PREVOST

WARRANTY BULLETIN

WB14-06G

DATE:	SEPTEMBER 2014	SECTION :	22 - HVAC
EXPIRATION:	SEPTEMBER 2016		
SUBJECT :	"BITZER" LARGE A/C SYSTEM IMPROVEMENT

Figure 5 Vehicle harness stripping

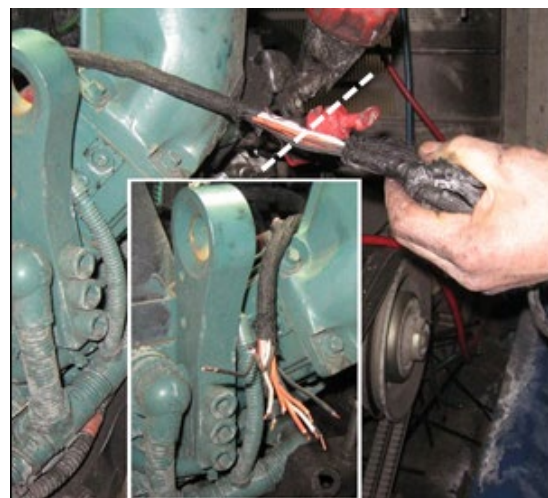
On vehicle side, take the main branch leading to the old compressor pigtail. Remove loom, tape above the pigtail junction. (Fig. 6)

Cut two inches (2in.) above junction and strip the wires to install ten (10) Deutsch terminals. See table.

Figure 6 Connector cavity reference

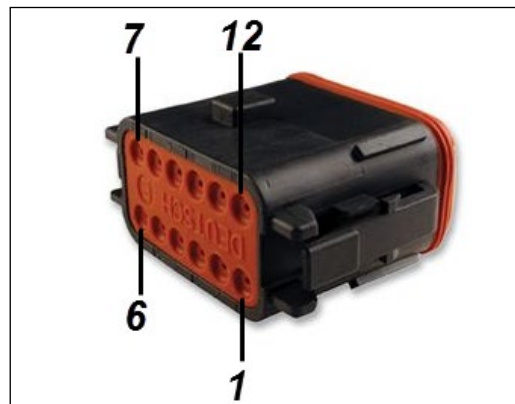
On Deutsch connector #563227 (C228), assemble the stripped wires with terminals and insert them in the indicated positions per wire circuit (Fig 14). Note the different circuit numbers for X3-45 coaches and other models

X3-45 Coaches	All other models	
Cavity	Circuit	Circuit	Terminal
1	77	77	562887
2	88	88	562887
3	93	79	562887
4 ¹	30	13	562887
5	77BA	77BA	562887
6	31	31	562887
7 ²	0RA2	0RA2	562887
8 ²	0RA2	0RA2	562887
9	88	88	562887
10 ¹	30	13	562887
11	-	-	561996
12	-	-	561996

¹ Positions 4 & 10: any wire printed "30 or 13"

² Positions 7 & 8: any wire printed "0RA2"

Figure 9 : Fitting Assemblies

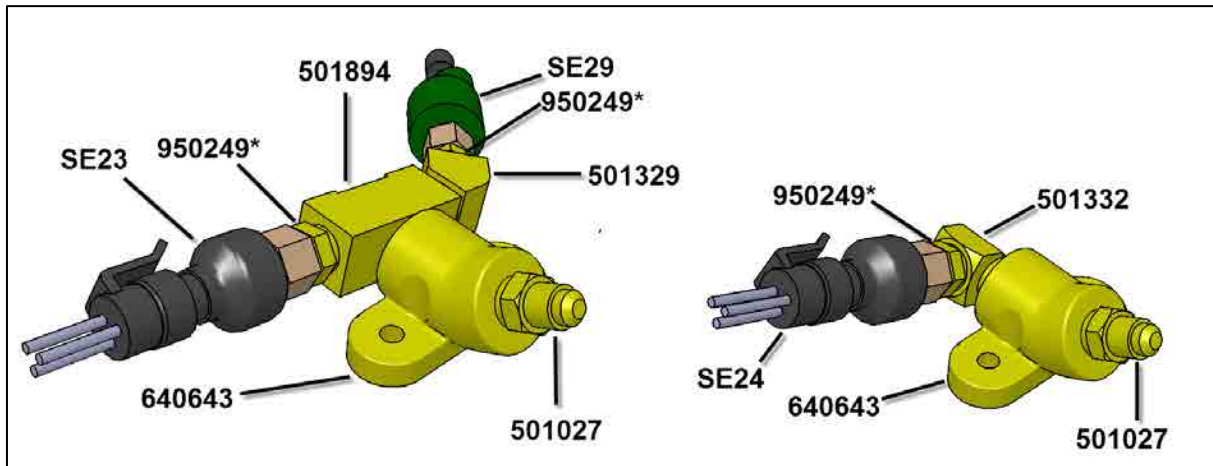
Assemble one each of the two fitting assemblies (Fig 9).

Apply Loctite 567 sealant.

Rotate tee and elbow at about 15degrees from 640643 mounting flange. (Fig. 11)

Install hoses 457743 on union fittings 501027 (No sealant required on SAE 45 connections).

Figure 12

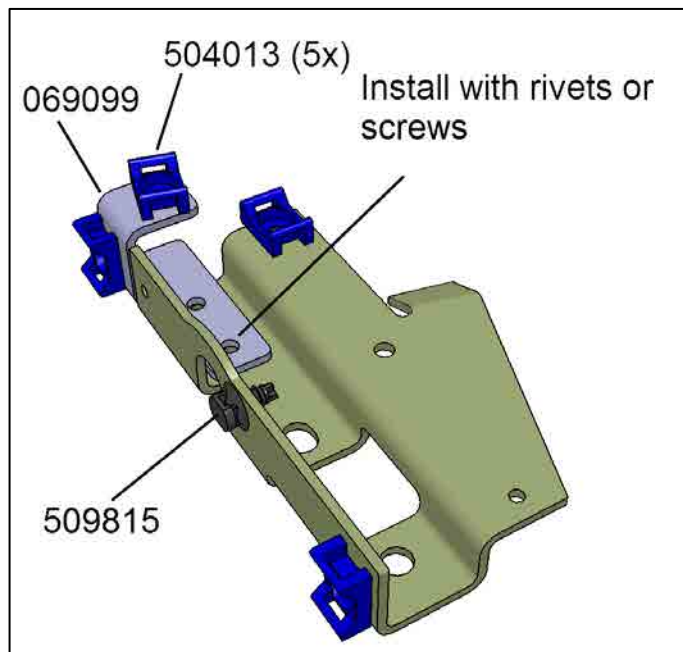
Addition of this support is recommended for all brackets, new and existing to route the unloader cable properly and avoid a sharp edge. You may install the bracket with screws or rivets.

If using screws, drill 7/32" holes using bracket 069099 as template. (Fig 12)

If using rivets, drill with a #10 (0.1935") drill.

Install with a pneumatic riveter if available using two #504379 rivets. Otherwise use two 5001241 screws and nut 5001180.

Figure 16: Drilling on the cable support

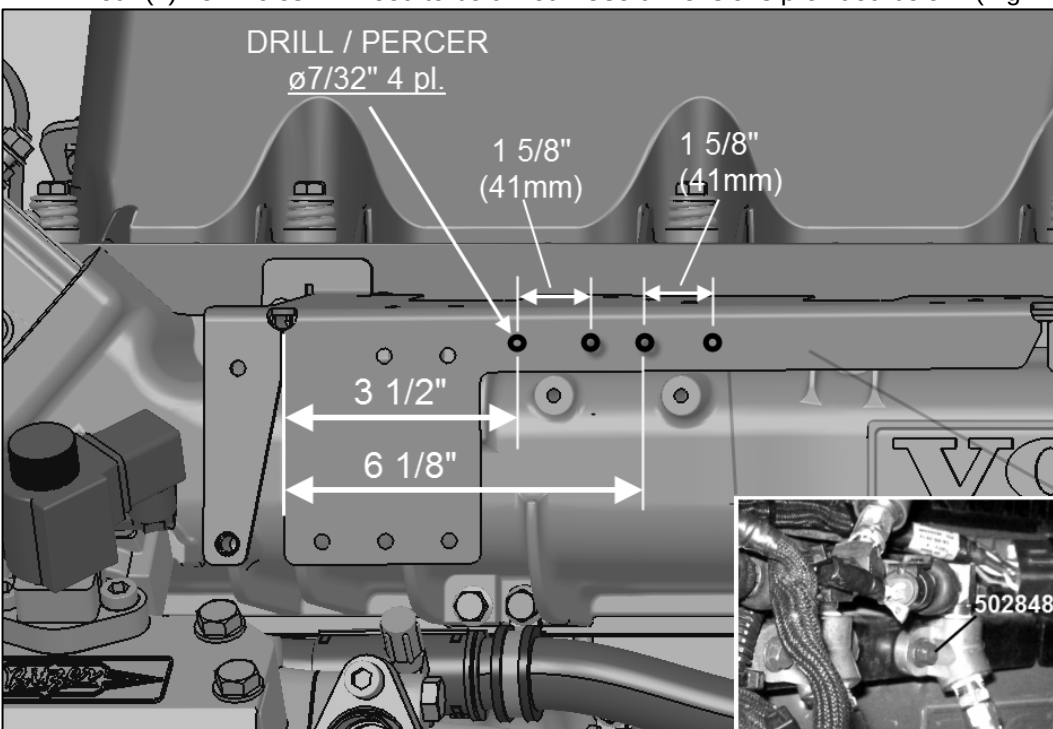
- 2.11.** Using cable tie anchor holes as reference, drill two new diameter $7/32''$ holes towards the center, 41mm apart.

Use flanged elbow **640643** as a drilling template to get 41mm dimension.

- 2.12.** On certain vehicles the cable support will not have reference holes. Four (4) new holes will need to be drilled. Use dimensions provided below. (Fig. 17)

Figure 19 –Clutch cable.

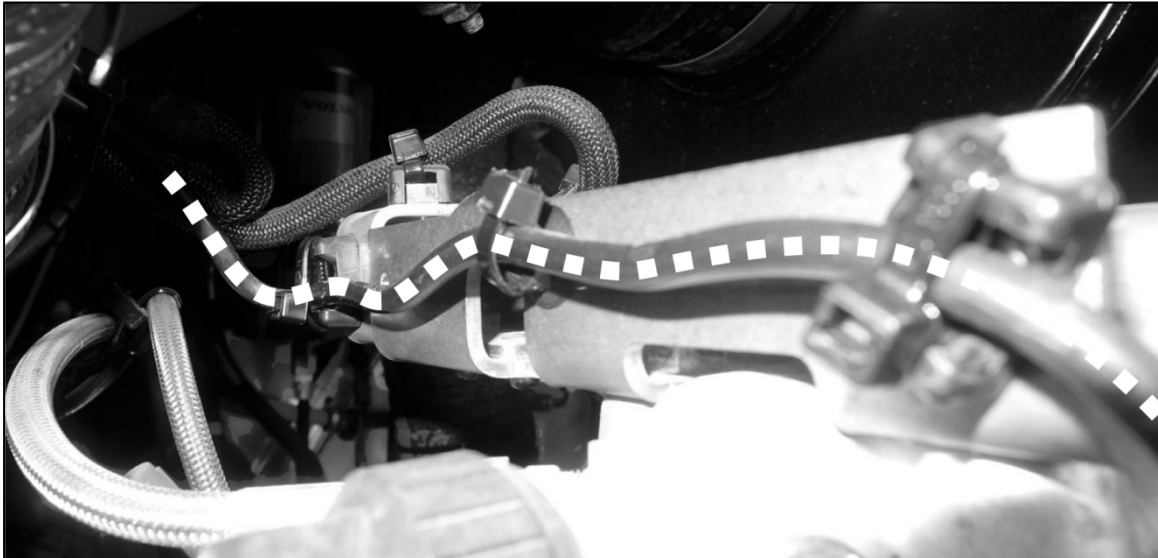
- 2.13.6. According to table, splice wires with butt slice #562228. Crimp and solder. Inspect to make sure you have a good crimp and solder.
- 2.13.7. Seal each wire with shrink tube. Seal over the two wires and cable isolation with the larger shrink tube. (Fig. 19)
- 2.13.8. Attach clutch cable along bracket as shown.(fig. 20)

Figure 20- Cable tie base and clutch cable.

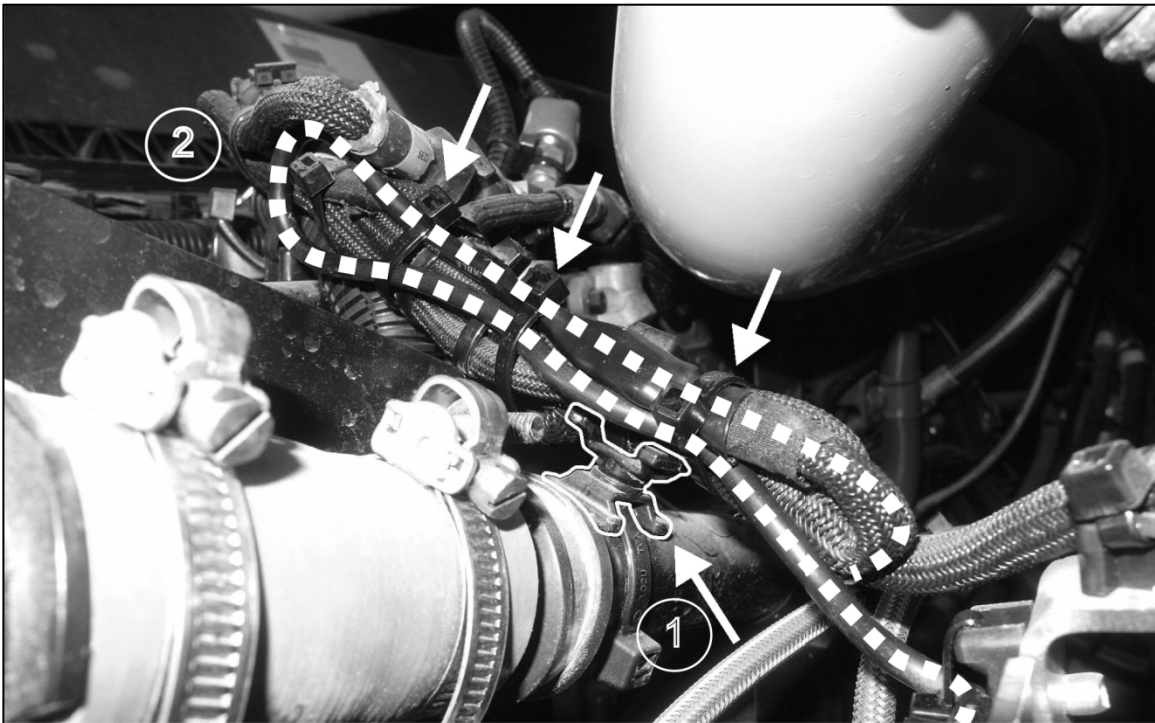
- 2.13.9. Install a swivel cable tie base 504751 slightly below the flexible section of the oil fill tube and attach harness. Secure main strand of harness to cable tie base (1) and route towards engine above oil fill tube. (fig. 21).
- 2.13.10. Attach the excess length of clutch cable (2) along main strand of harness as shown in fig. 21.

Figure 23 Harness routing to remote instruments on engine.

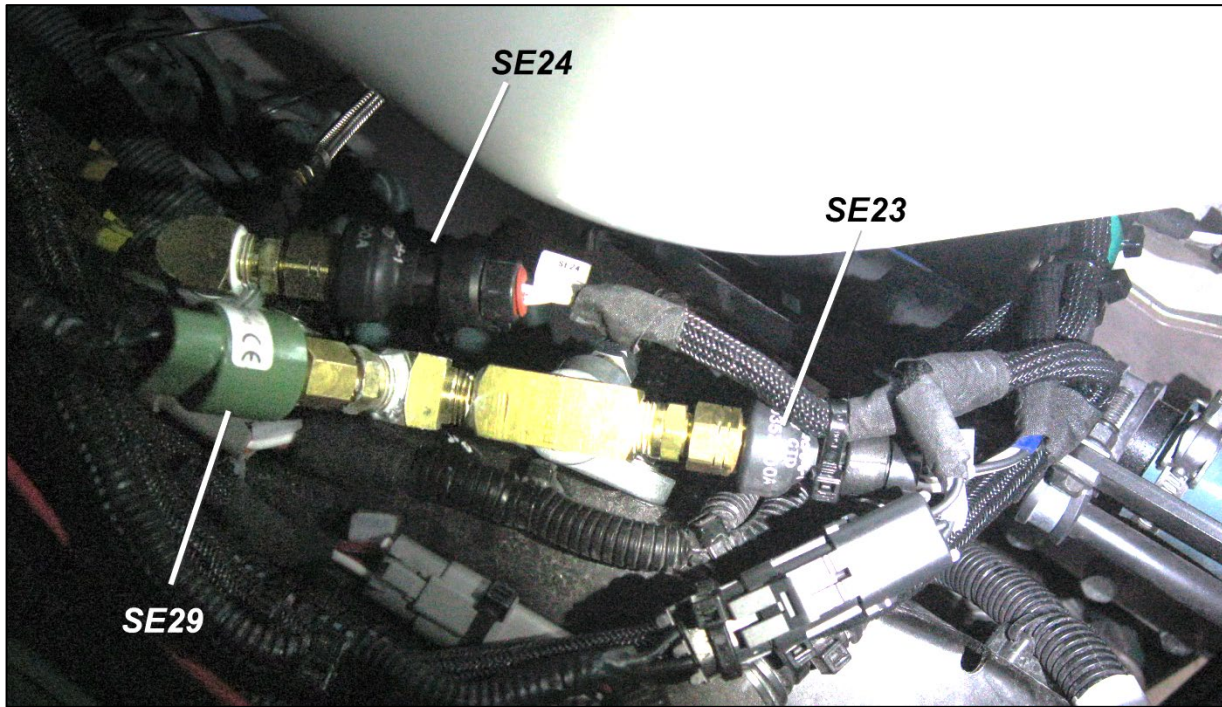
Route harness towards engine and connect to the transducers and switch installed on the fitting assemblies. (Fig. 24) Secure with cable ties.

Figure 24 : SE29, C228.

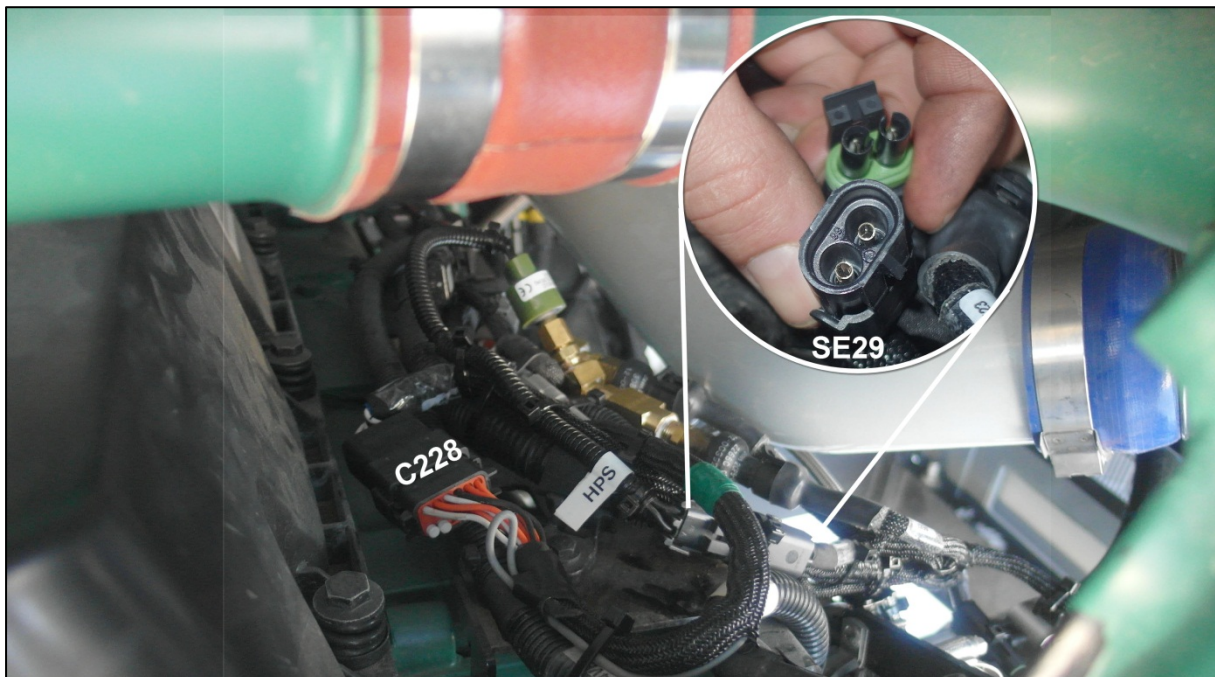
Connect Harness to C228 and secure connector according to best practices, making sure deconnection is possible.(Fig. 25)

Inspect Pressure Switch SE 29 connector to make sure the pins are mating.(Fig. 23)

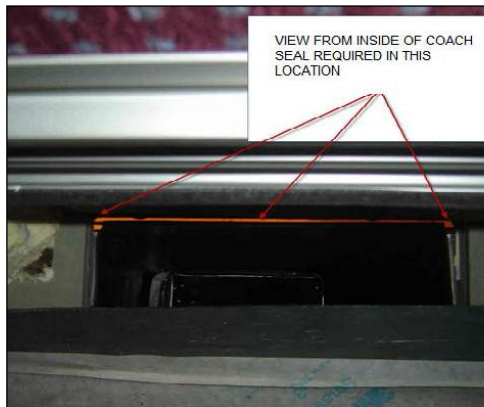
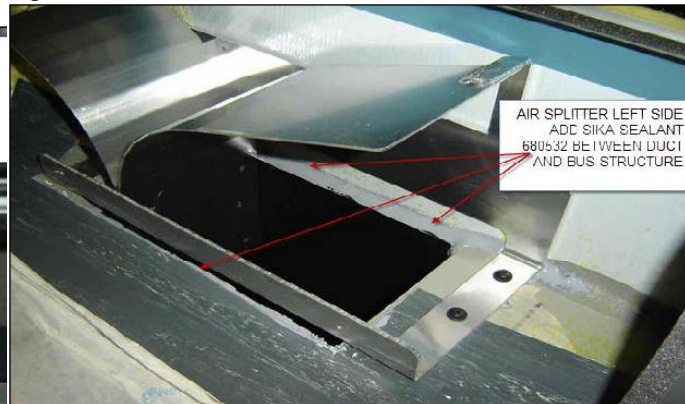
Inspect before performing any work.
Some vehicles up to **E-5526** may present a gap between the road side air flow splitter, floor and vehicle structure.

To avoid removing the passenger side floor ducts, sealing can be performed from the evaporator compartment.

Add a Sika sealant joint #680532 between discharge duct and structure and between duct and floor.

Figure 28

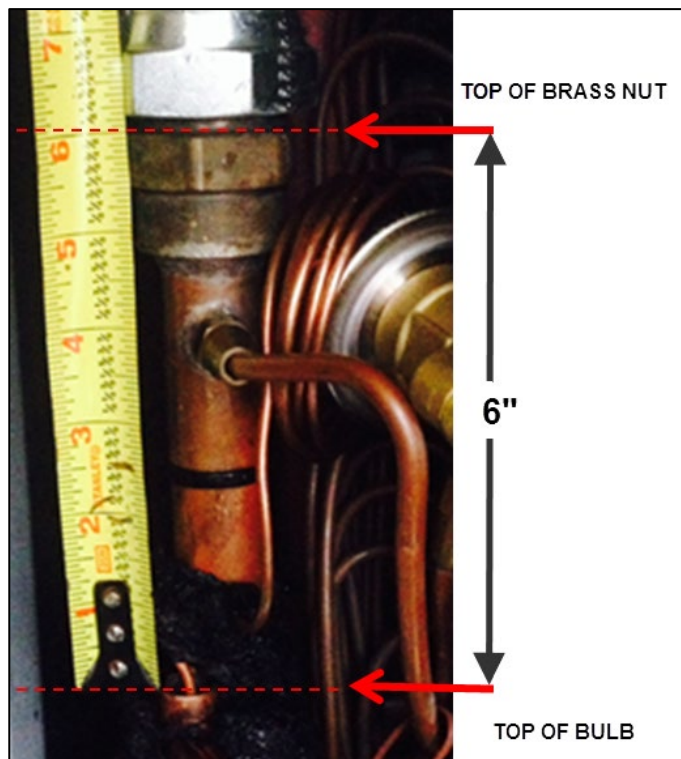
On the evaporator, inspect the expansion valve bulb position.

Adjust to 6" from top of brass nut, as indicated in fig 31.

Clean thoroughly the contact surfaces on the tube and on the bulb with a "scotch brite" type scouring pad.

Isolate bulb and tube section with insulating tape #680091.
